Access Compliance Report

Public Rights-of-Way

(Curb Ramps)

Intersection ID: 23697	Main Street: ABBOTSWOOD_DR	Cross Street: COLONY_RD	Location: SE
ADA ID: B6A66F5E453E	Ramp Type: ParaDiag	Initial Pass/Fail: Fail	Overall Compliance: No
			Severity Score: 26.25

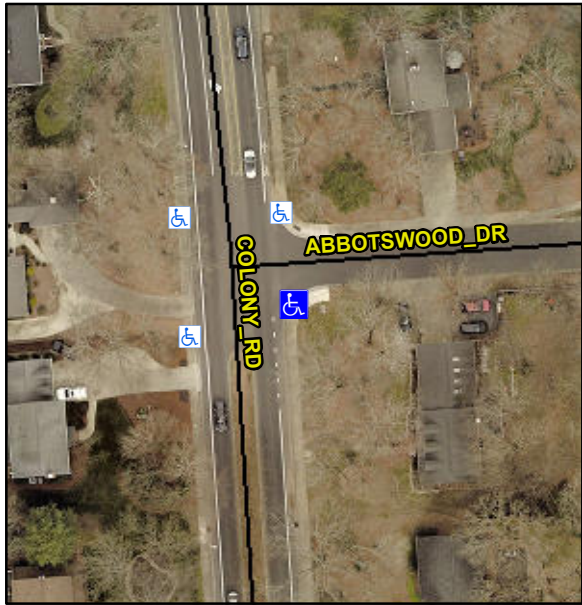
Codes/Mitigation Info/Possible Solution			Field Measurements/Component Compliance					
	Possible Solutions:		Compliance	Description	Data	Compliance	Description	Data
	Remove & Replace Curb Ramp With Two New Directional Ramps or Equivalent.		N/A	Ramp Length LT (in)	56.0	N/A	Ramp Length RT (in)	32.0
			Yes	Ramp Width LT (in)	70.0	Yes	Ramp Width RT (in)	60.0
			No	Ramp Slope LT (%)	14.5	Yes	Ramp Slope RT (%)	5.2
			No	Ramp XSlope LT (%)	2.8	Yes	Ramp XSlope RT (%)	0.3
			N/A	Landing Length (in)	N/A	N/A	DWS Provided?	N/A
			N/A	Landing Width (in)	N/A	N/A	DWS Contrast?	N/A
			N/A	Landing Slope (%)	N/A	N/A	DWS Length (in)	N/A
			N/A	Landing X Slope (%)	N/A	N/A	DWS Full Width?	N/A
			N/A	Landing Curb? (Y/N)	N/A	N/A	DWS Offset (in)	N/A
Surveyor Notes:			N/A	Shared Landing?	N/A			
PROW/ADA:			N/A	Gutter Ponding?	N/A	N/A	Gutter Slope (%)	N/A
R304.3.2, R304.5.3			N/A	Gutter Lip Ht (in)	N/A	N/A	Gutter X Slope (%)	N/A
